Document Number: IMX25CE Rev. 7, 04/2014

# **Chip Errata for the i.MX25**

This document details all known silicon errata for the i.MX25. Table 1 provides a revision history for this document.

Figure 1. External Divider Schematic

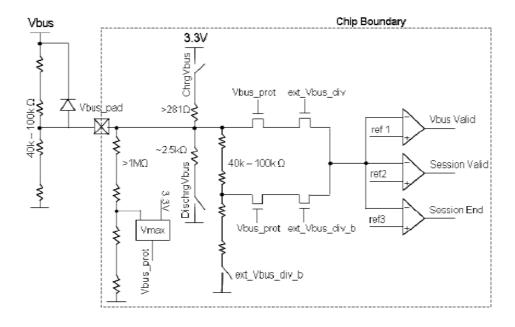
Case 1: The system needs OTG functionality with HNP/SRP. There are two steps:

1. Add an external divider (including two resistors) with a Schottky diode to the USBPHY1\_VBUS pin. The external divider decreases VBUS from 0–5.25 V to 0–1.37 V (the external VBUS divider ratio is 0.2626). Figure 1 shows the schematic of the external divider; the upper resistor is 51.1 k $\Omega$  and the lower resistor is 18.2 k $\Omega$ ; the Schottky diode needs to tolerate > 5.25 V, so a higher rating (> 8 V) value is preferred. The current limit is approximately 8 mA in forward-bias mode and low on voltage (<= 0.7 V) for a 3.3 V supply and 8 mA current.
